ADDENDUM NO. 1

**Administration Building Renovation Re-bid
Compton Community College District**

tBP Project. No. 20987.00

tBP/ARCHITECTURE

drawing no.:
A7-1
drawing of

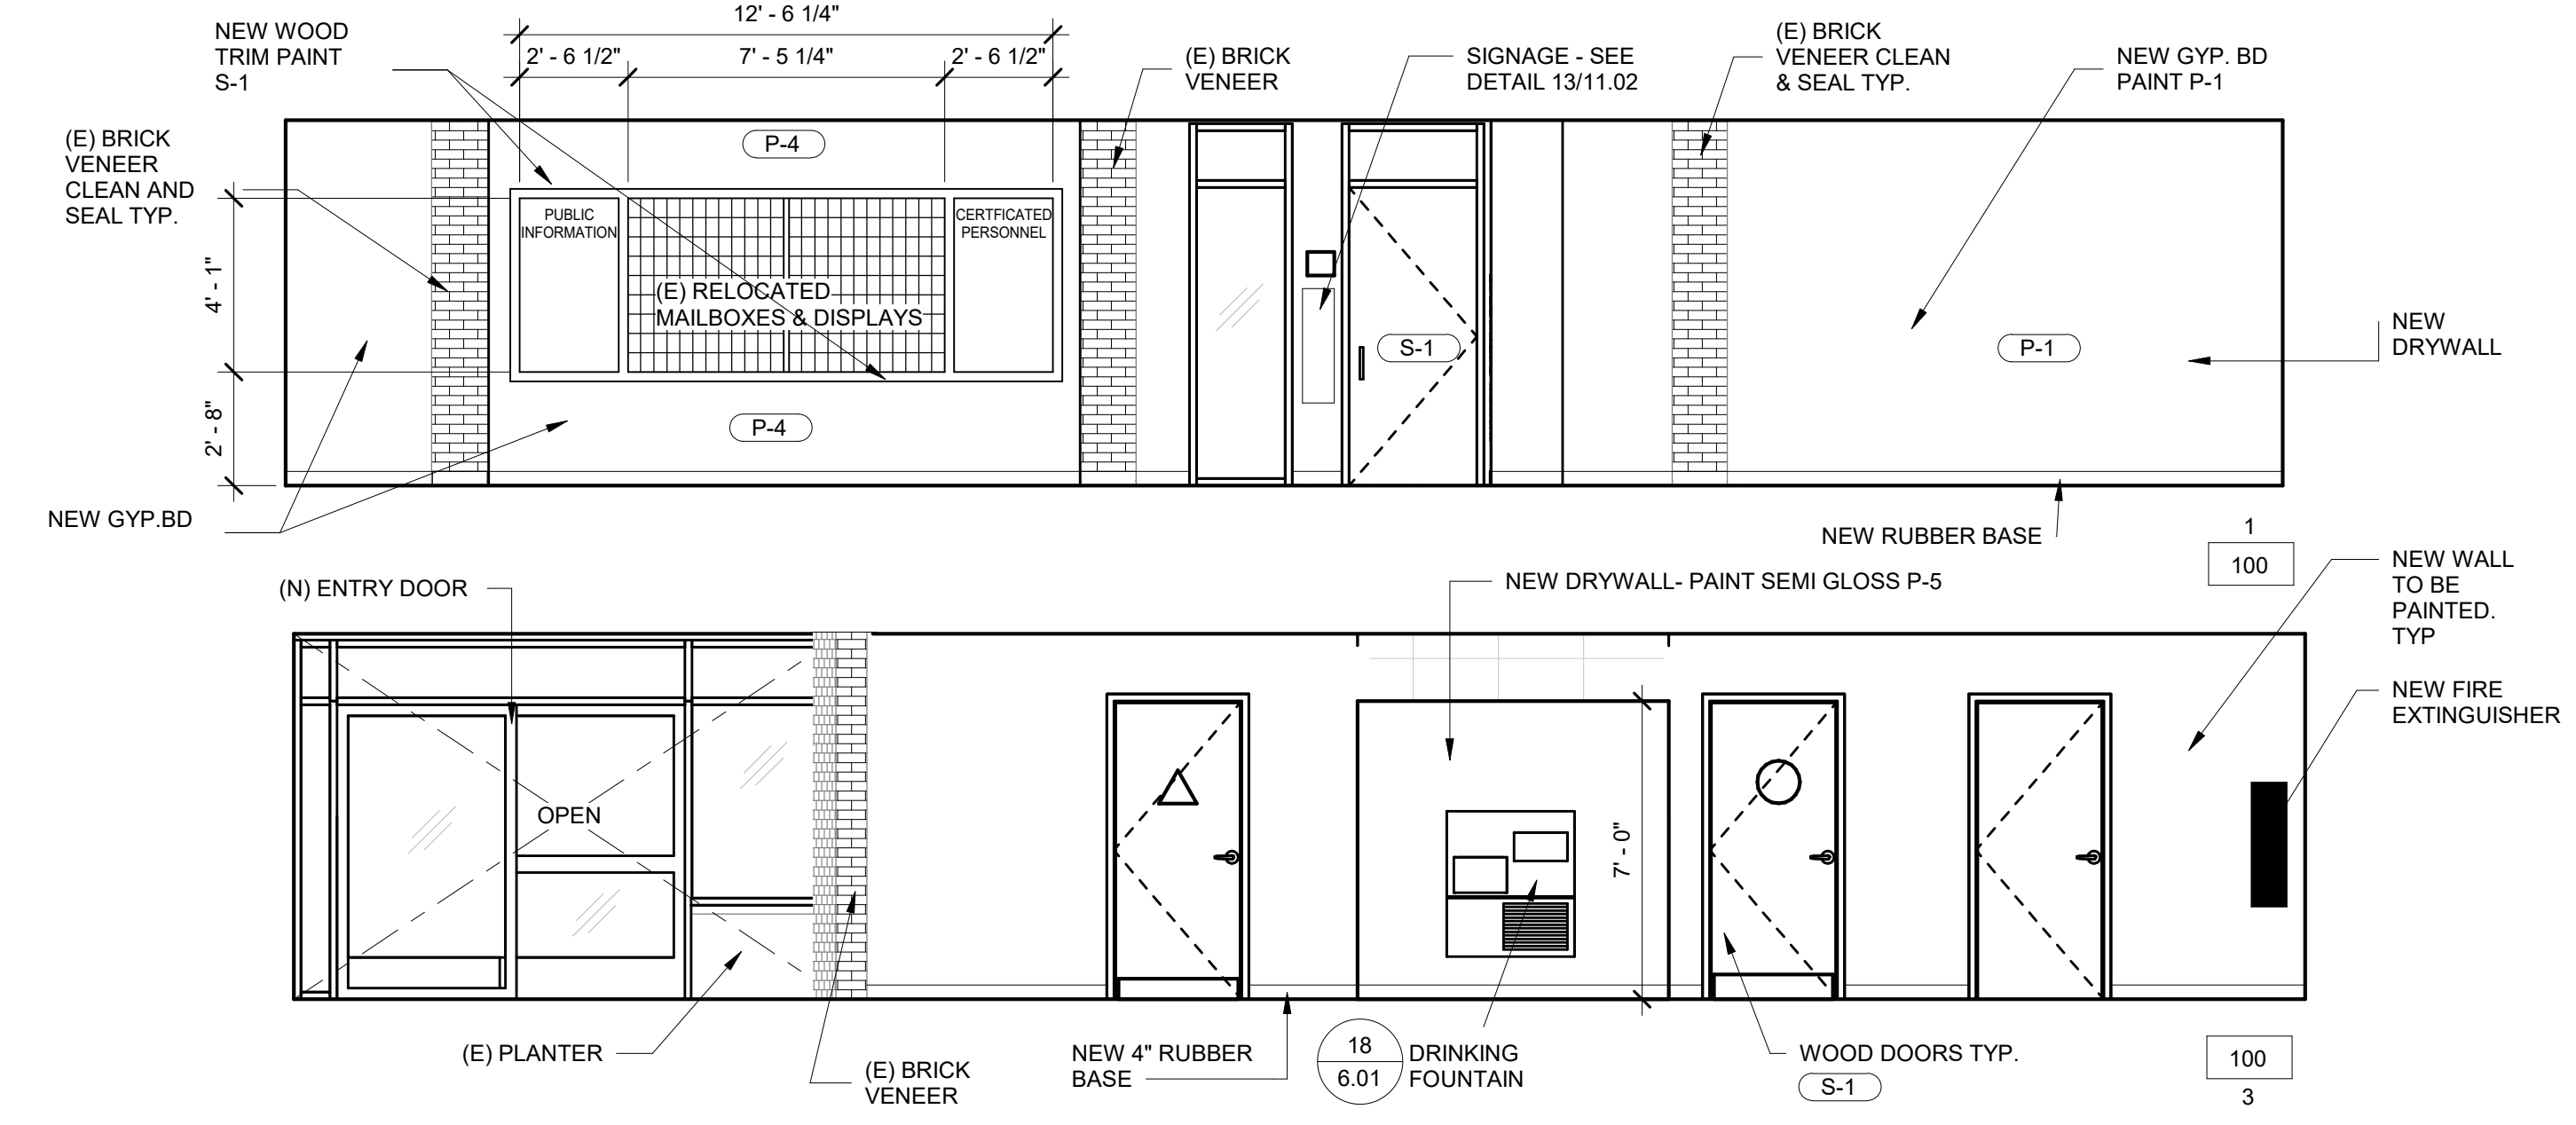
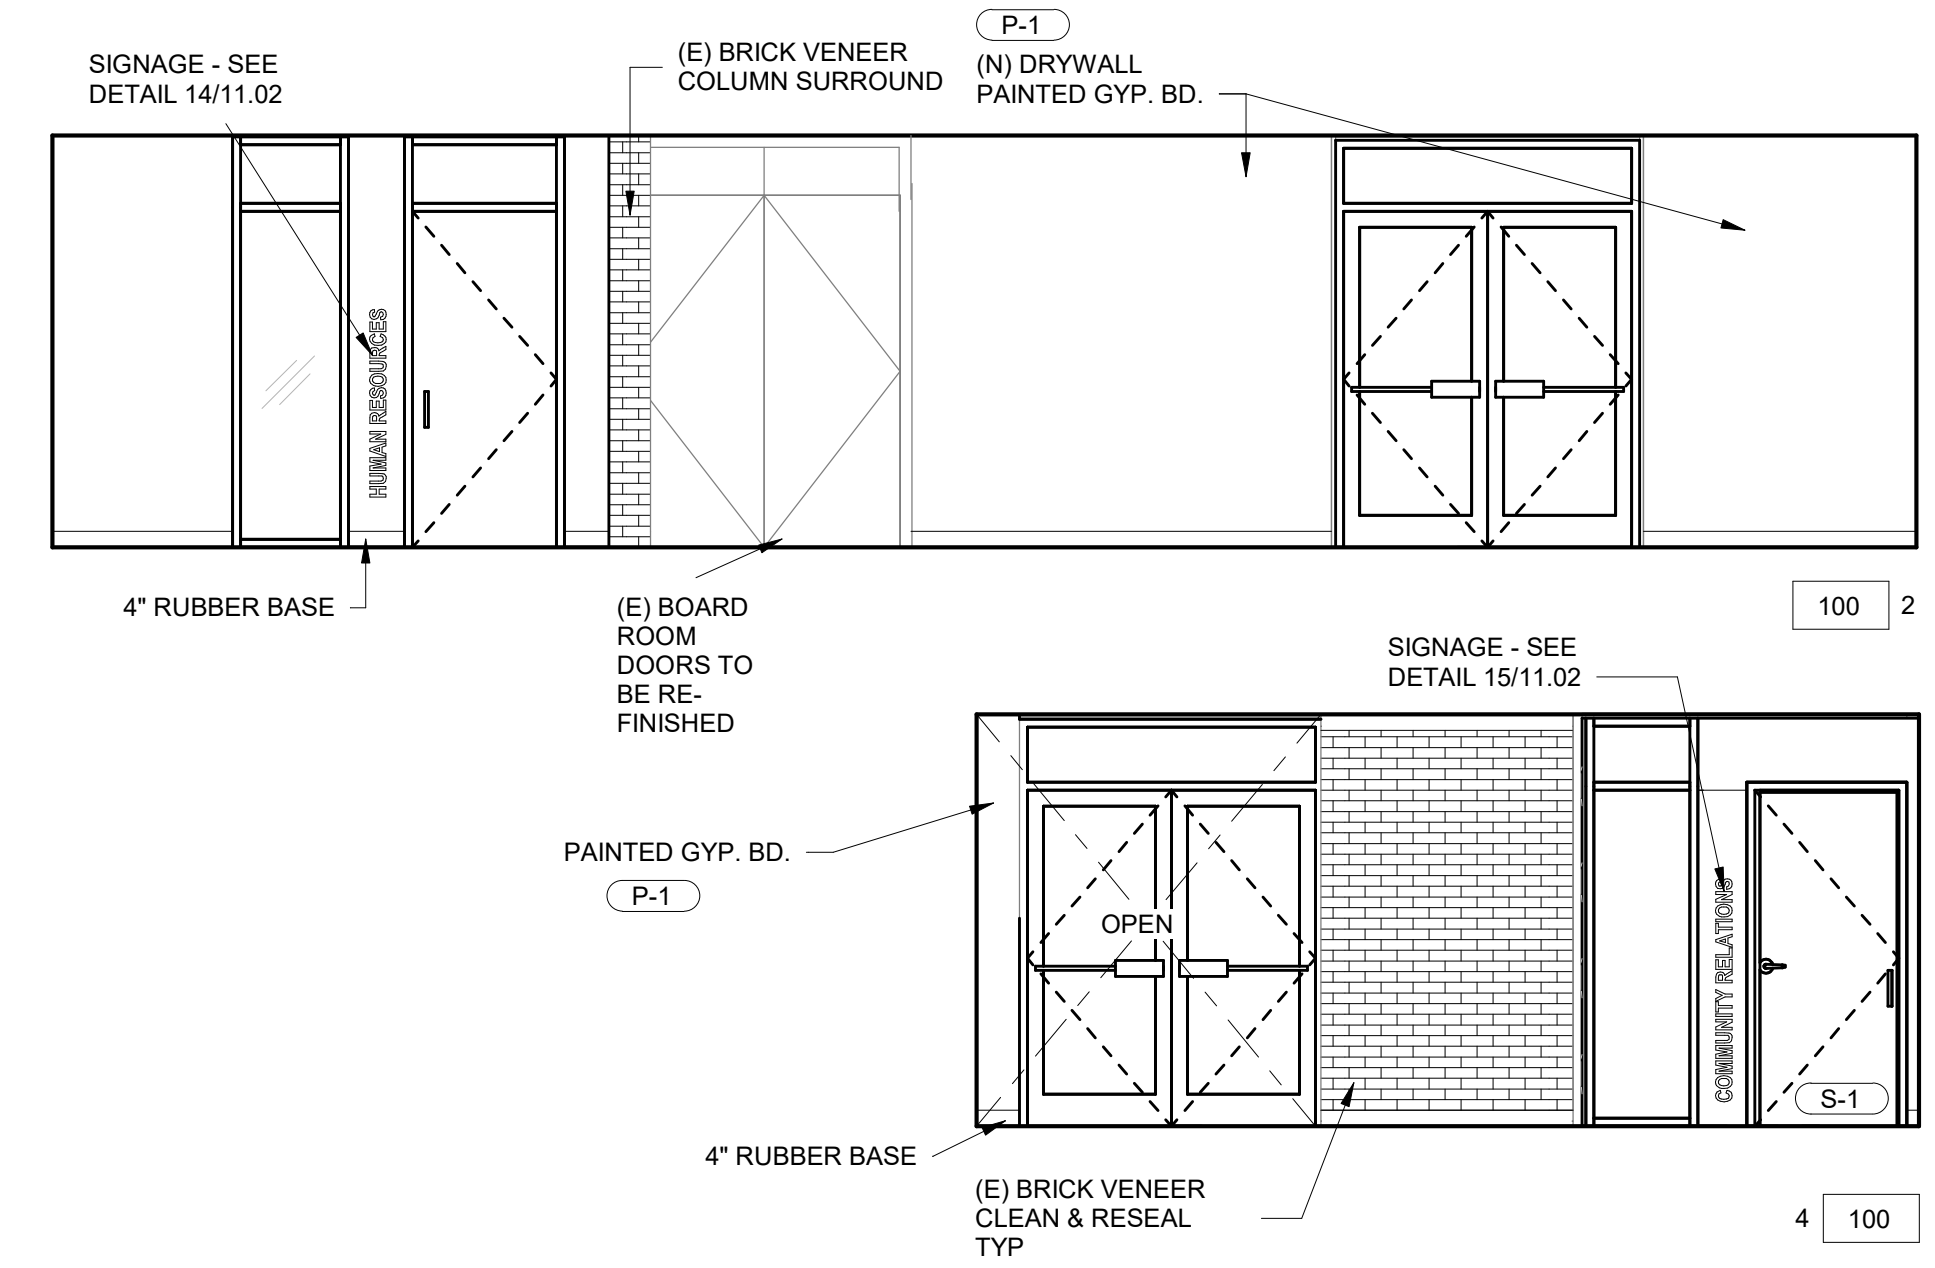
9. Revised SHEET A7-1 ENLARGED TOILET PLAN

- a. Toilet Accessories Keynotes revised to ADD OFCI at non-ADA stalls.
- b. Added note for align wall grout with floor grout.
- c. Corrected some graphics at Women's Lounge.
- d. Shows DF relocation.
See attached revised Full size sheet identifying revisions included as part of this addendum.

drawing no.:
A8-2
 drawing of

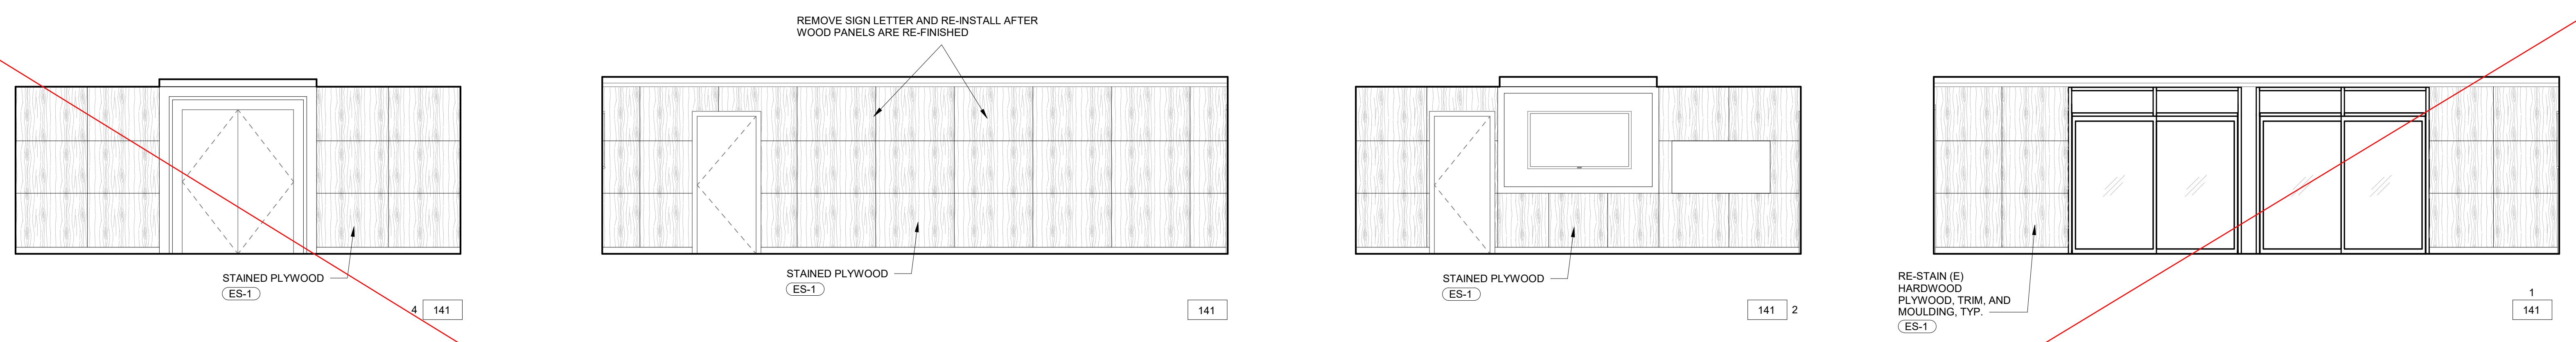
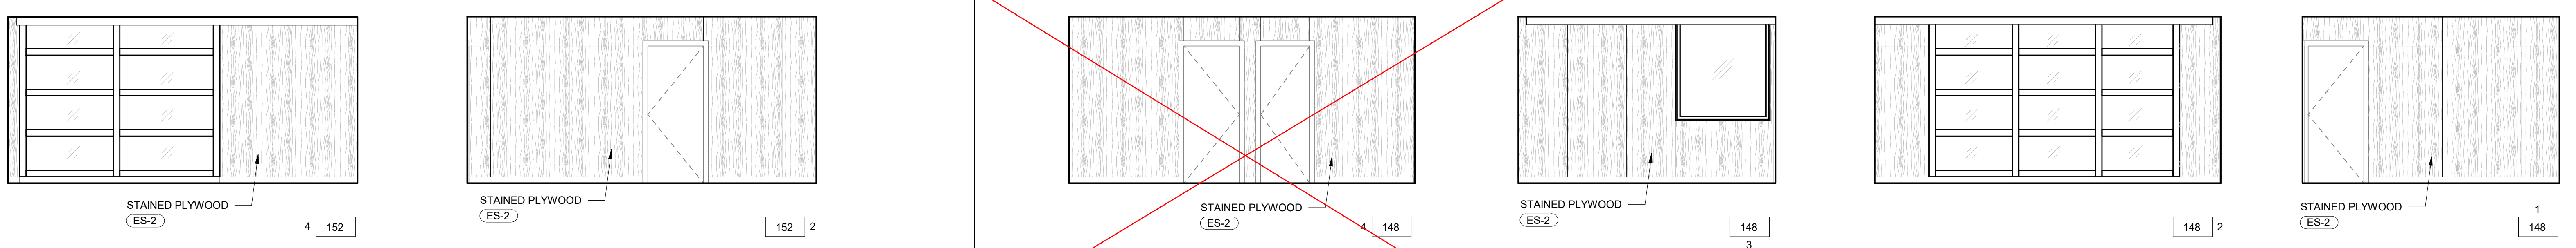
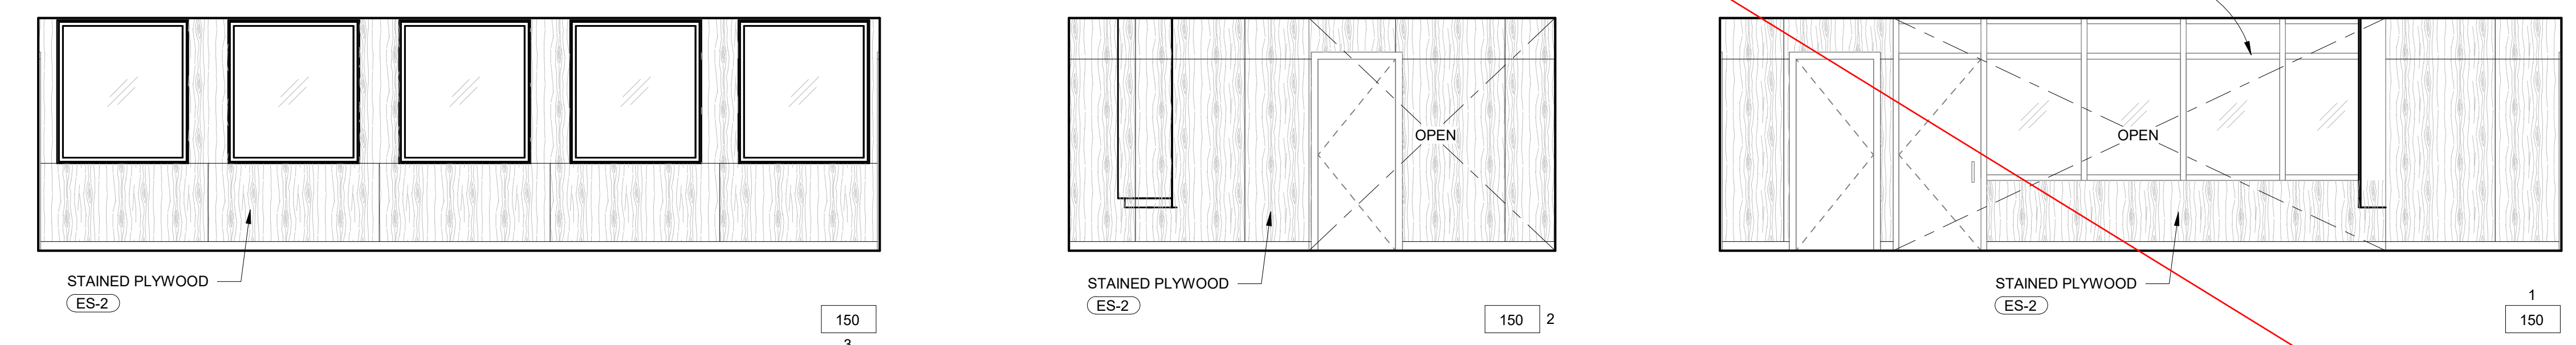
11. **Revised SHEET A8-2 INTERIOR ELEVATIONS**
- a. Removed wood paneling re-finish scope shown in this sheet.
See attached revised Full size sheet identifying revisions included as part of this addendum.
